Second Revision No. 5156-NFPA 72-2023 [Detail]

Committee: SIG-ECS

Figure A.24.3.10.1.1 A-NAC CM Internal Block Diagram.

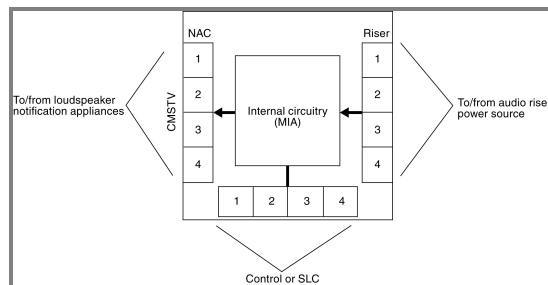
A-NACs using CMs that are not integrated directly into the control unit(s) shall include their module insertion adjustment (MIA) in circuit designs.

Figure A.24.3.10.1.1 provides a block diagram of the internal sections of a typical A-NAC CM. For A-NACs, the module insertion adjustment (MIA) is factored into the calculations.

Committee Statement: Added new section to clarify how to calculate Audio Notification Appliance Circuits (A-NACS). The goal is to standardize how A-NACS are calculated so that the design, authority, installation, and related communities are all using the same methods. Specific requirements are provided for how to prepare and submit voltage drop calculations because vertical lengths and actual conduit lengths are frequently left out of voltage drop calculations. This will help to standardize the review process.

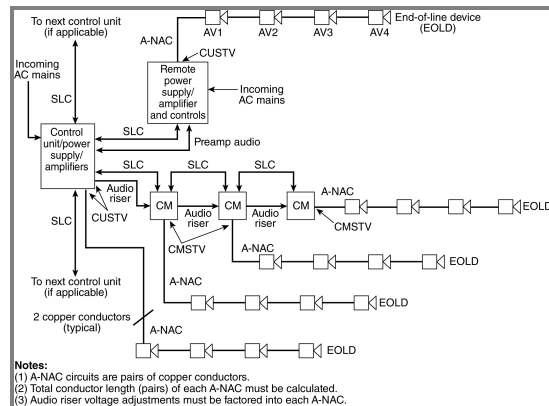
A-NACs shall be designed based on one of the following methods of calculation:

Line Loss Calculations. This is the key design factor. All conductors in a circuit must be considered, including drops, risers, whips, service loops, and any other conductors in a circuit. There are two acceptable methods, as follows:

- (1) End-line-loaded (ELL): ELL circuits are designed and tested based on the total circuit resistance and loss and is also referred to as lump-sum loading. This method assumes that all the appliances are at the end of the circuit and are activated at one time. This is the most conservative method and is the recommended design method for all systems.
- (2) Point-to-point (PTP): PTP circuits are designed based on the individual segment and tested on total resistance and loss. This method requires that the designer know the exact wire distance between every appliance. If the installed values are different than the design values, the circuit might not work correctly. This method requires close coordination with the design and field work.

Figure A.24.3.10.2 A-NAC End-to-End Concept Diagram.

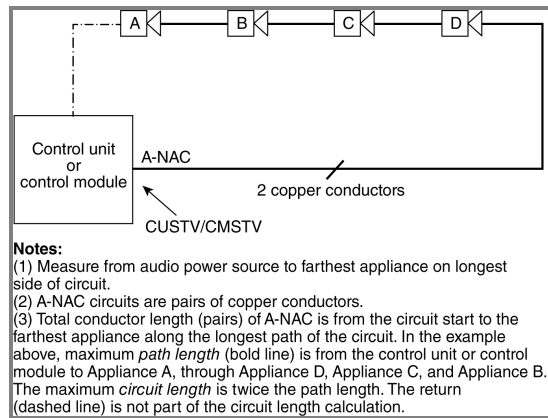
Class B circuit length shall be calculated from the circuit start to the last loudspeaker on the circuit.

Figure A.24.3.10.2 depicts the overall audio power flow and areas of concern for a typical system.
